PLANNING BOARD AGENDA Tuesday July 6, 2021 @ 7:00PM

**Subject: Blueberry Lane
Proposed Self Storage Facility
Special Permit/Site Plan Review**

Please find this response letter to Quinn Engineering, Inc. review dated June 1, 2021. For clarity, the original comment is shown and our response is shown in italics.

SITE PLANT LIST

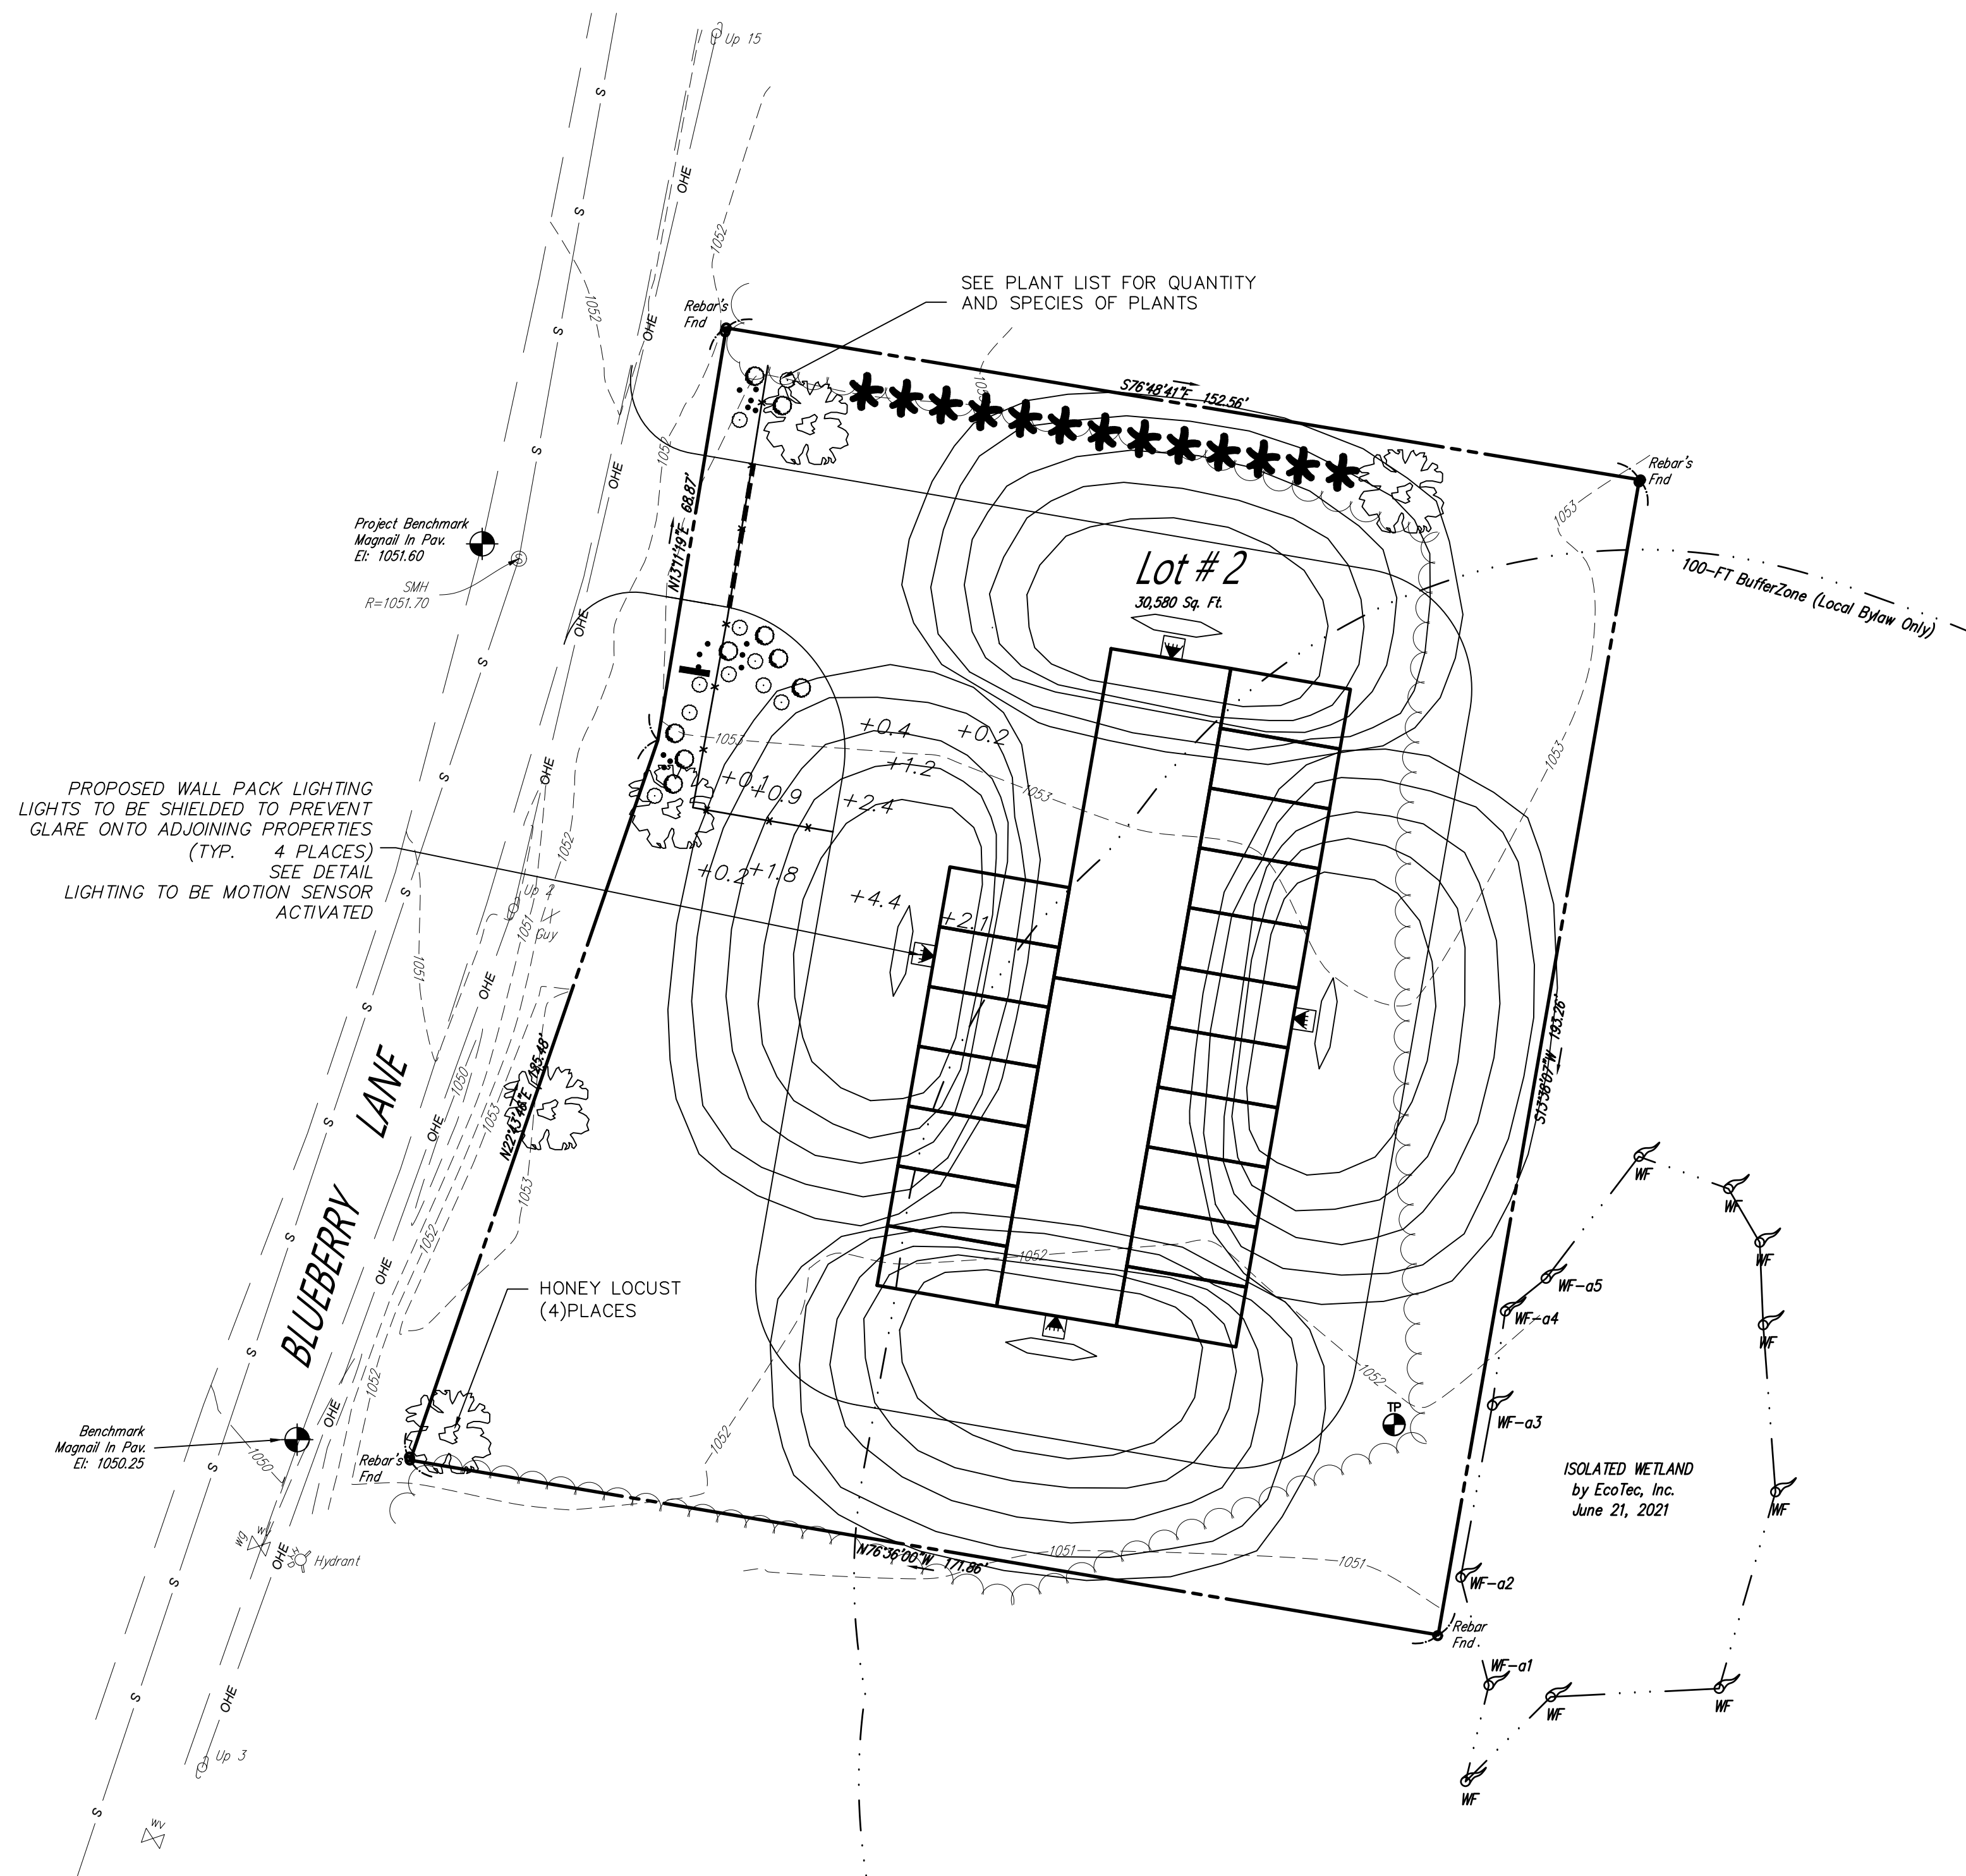
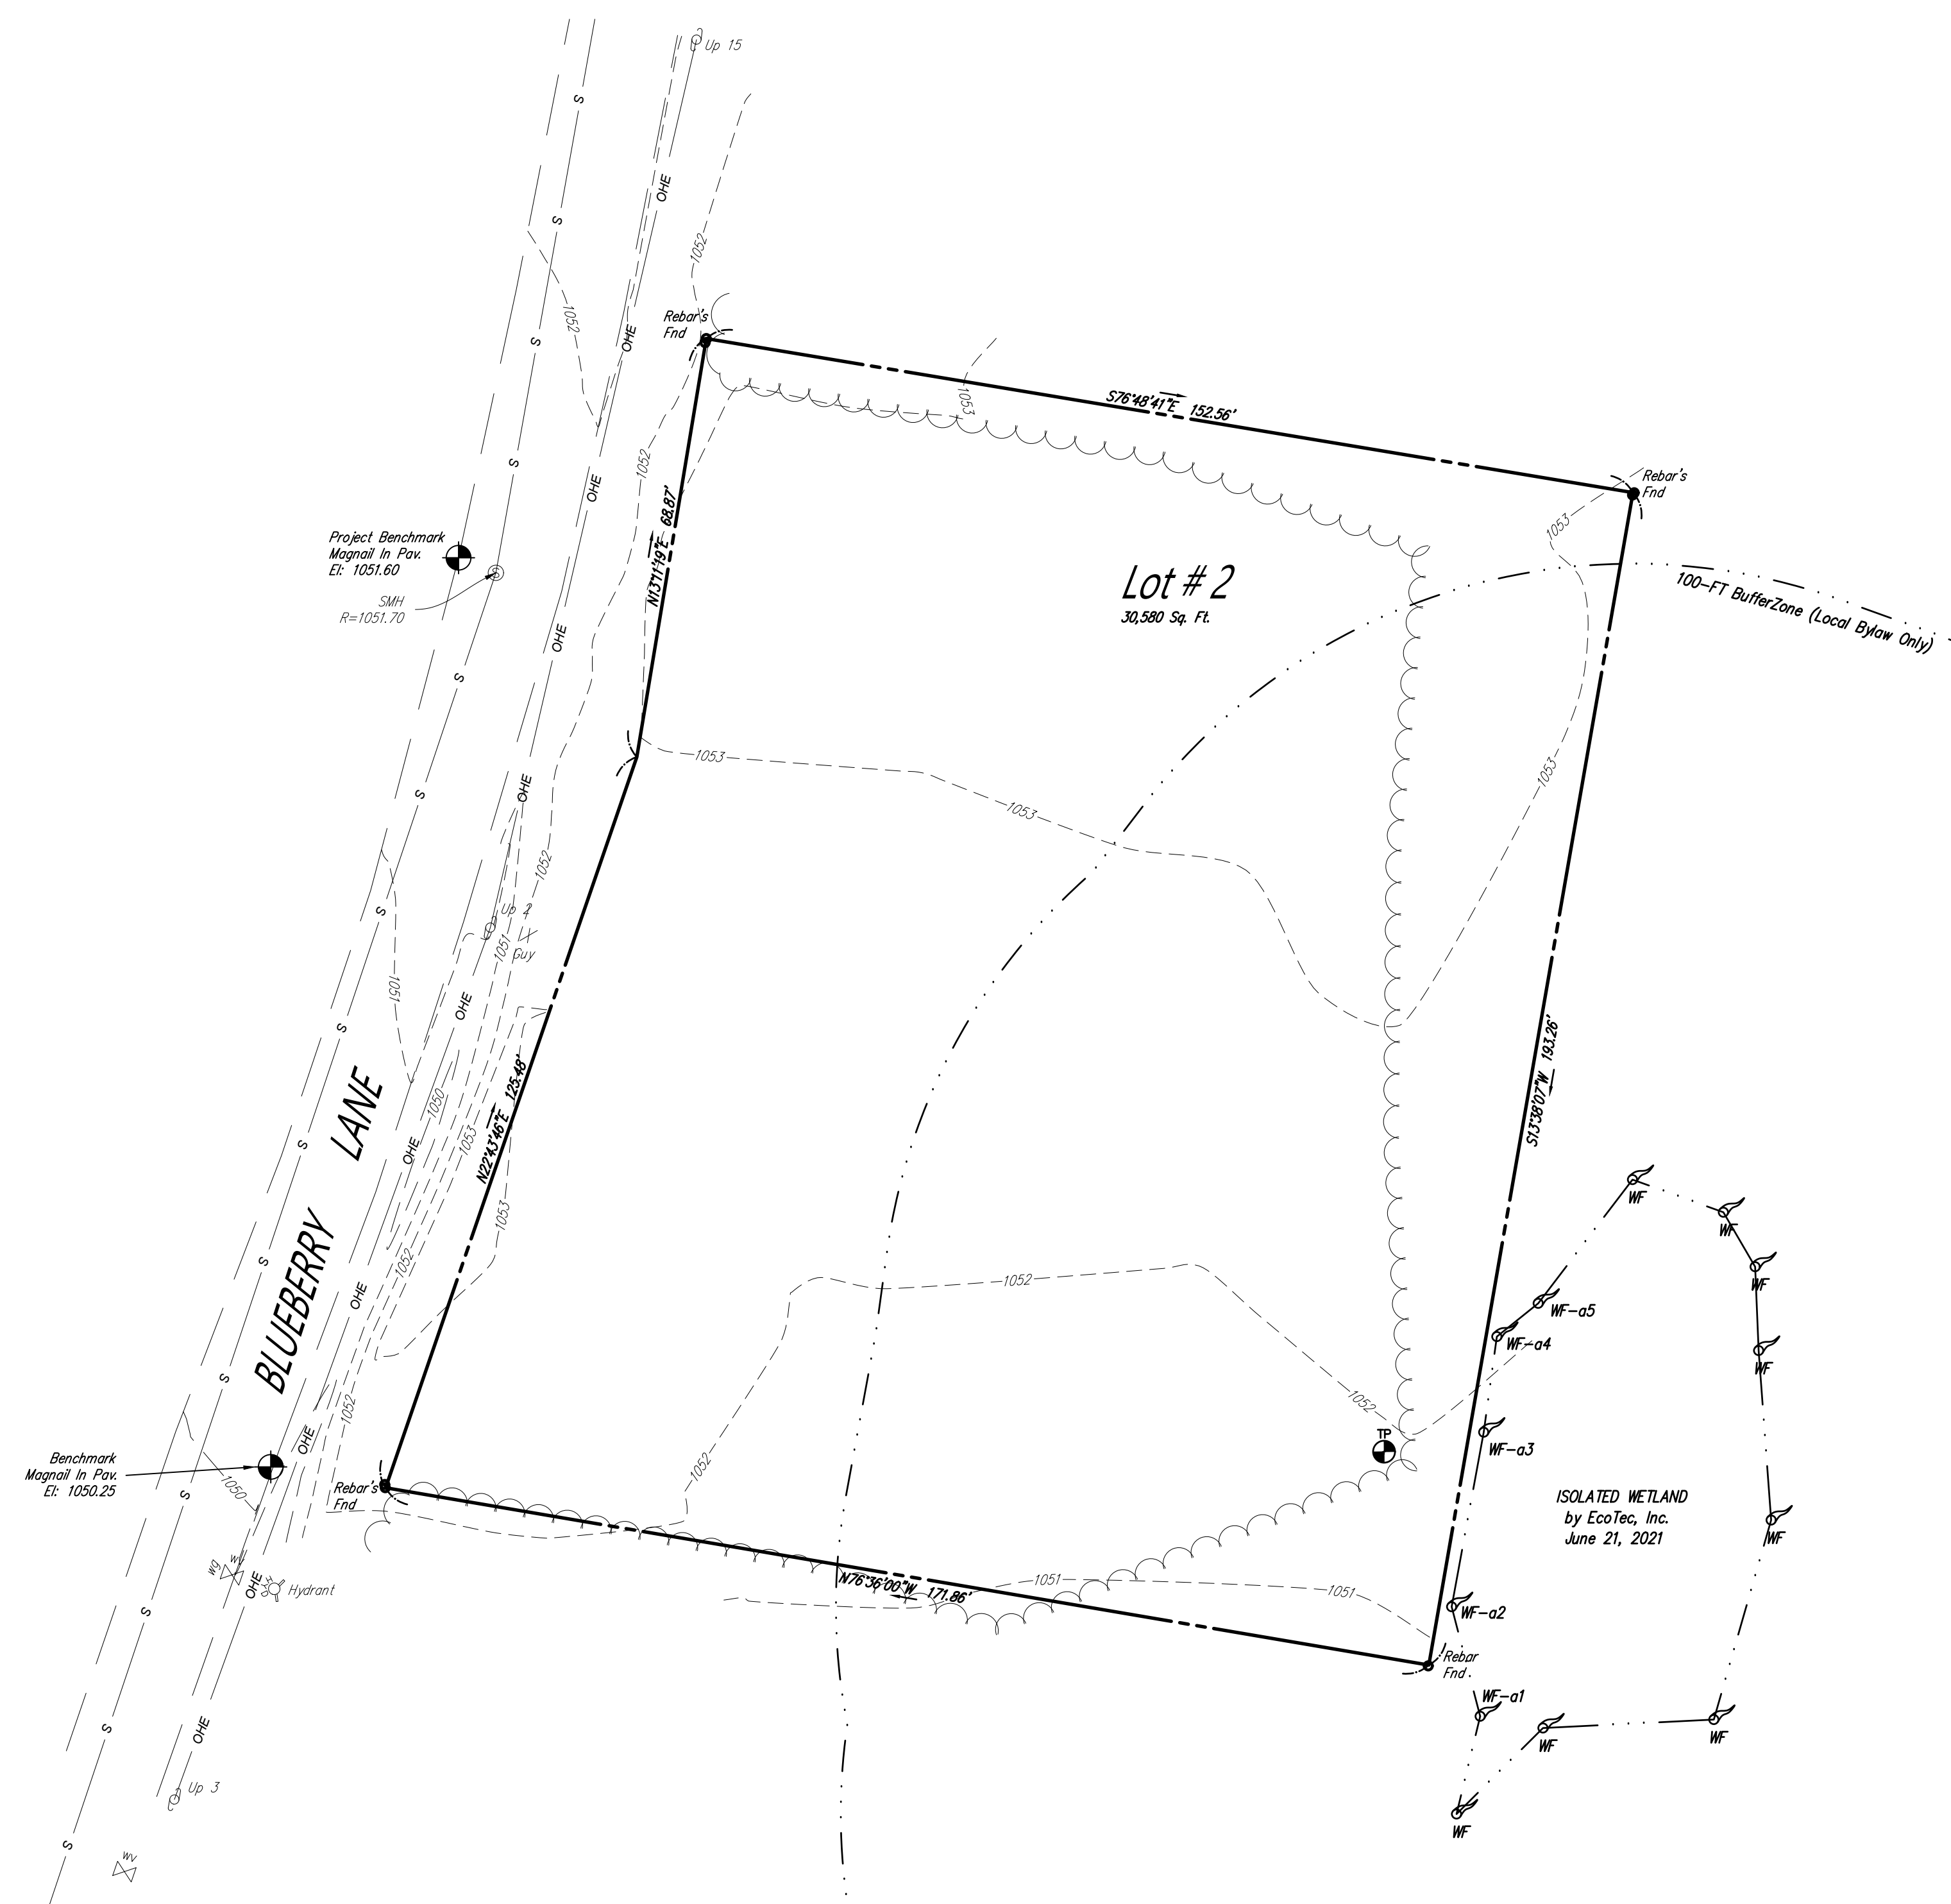
3. Sheet L-1 calls for landscape plantings in the same location as handicapped parking spaces in the front of the site. Plans must be revised to eliminate the conflict. *The landscaped area has been revised as to not be in conflict with parking spaces.*

4. Landscaping
The Landscape/Lighting Plan (Sheet L-1) shows 17 *arborvitae* in the Site Plant List, but doesn't indicate the location of these *arborvitae* on the plans.

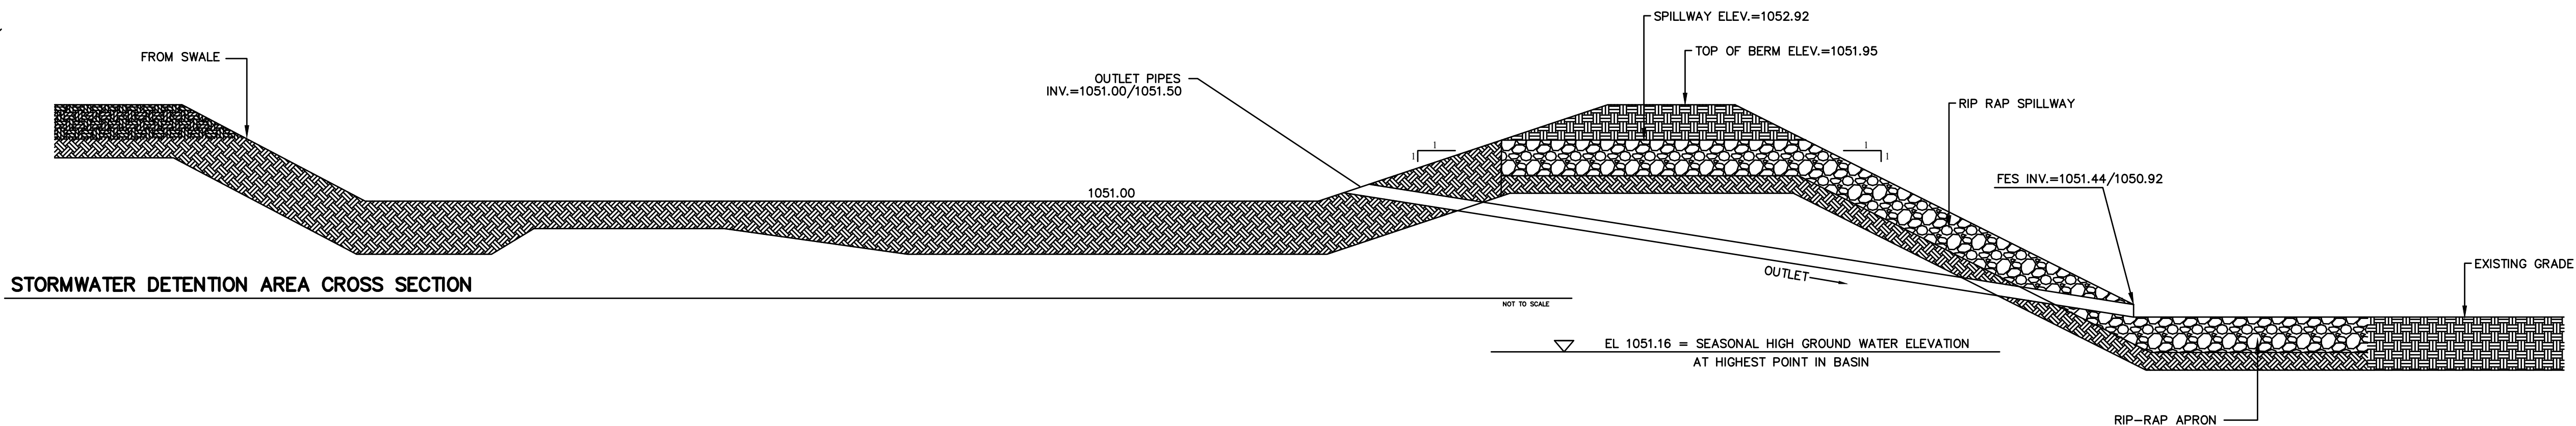
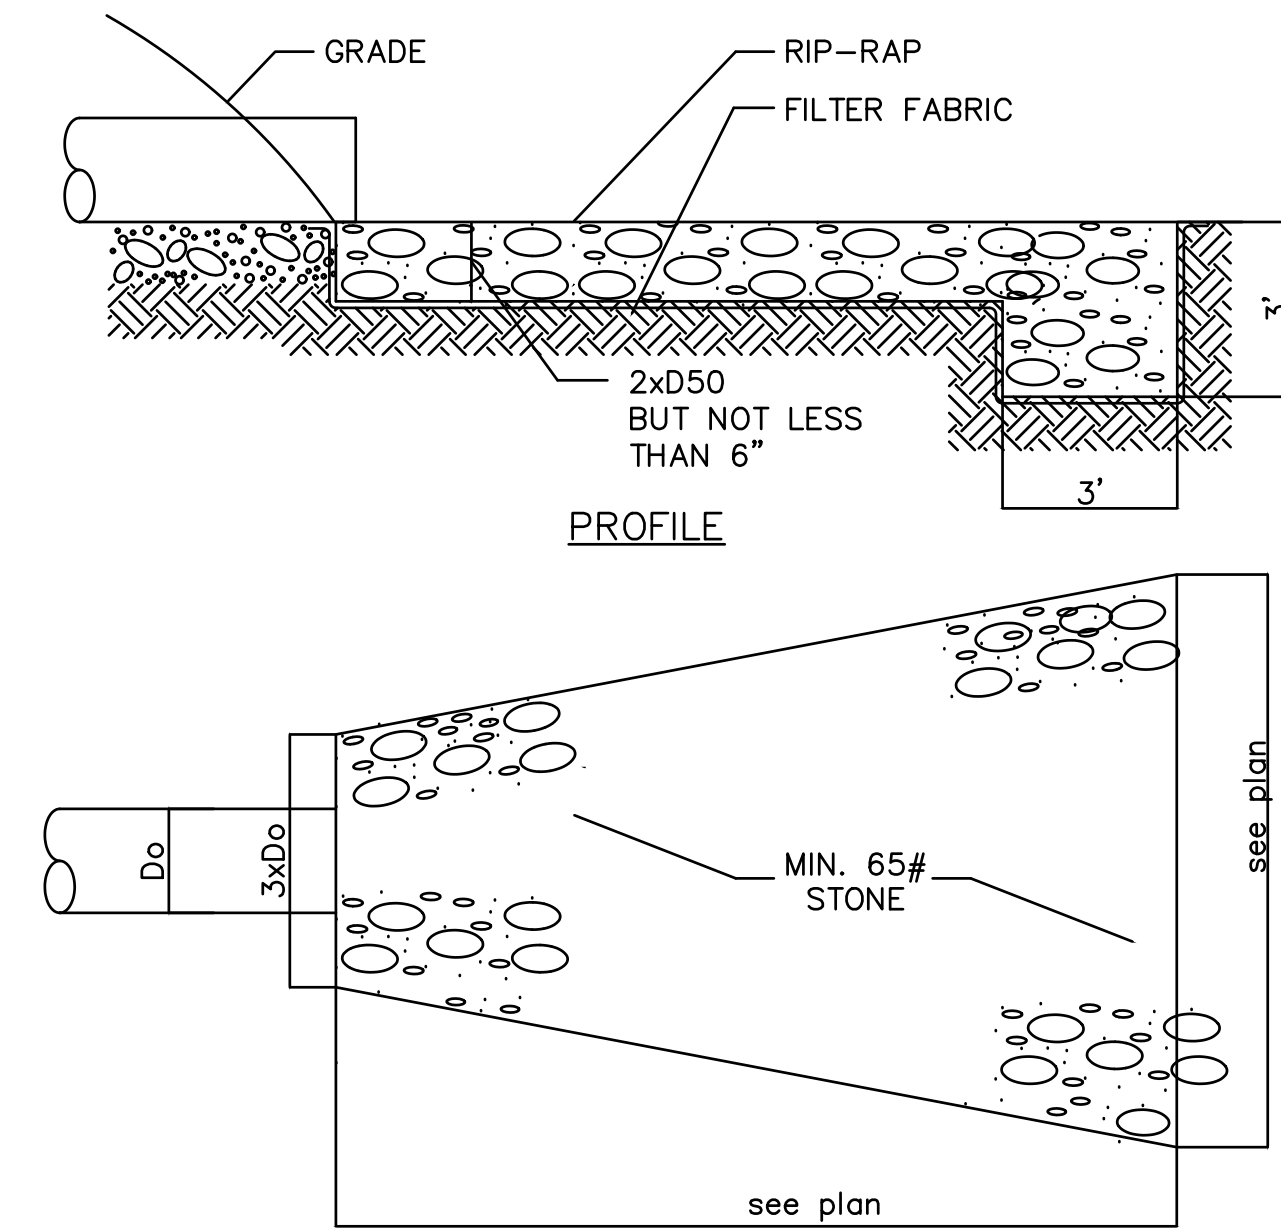
- b. A roof runoff collection system is not called for on plan. Stormwater which falls from the roof to the ground surface will erode the gravel/asphalt grindings finish. It is recommended that some means of protection the surface from erosion be called out on the plan. *A roof collection system has been provided on the plan to capture roof downspouts and route to the detention area. Inverts have been shown.*

- d. Plans call for a 1:1 side slope on the detention area; the Massachusetts Stormwater Handbook recommends a maximum slope of 3:1. *The side slopes have been revised to a 3:1 slope.*
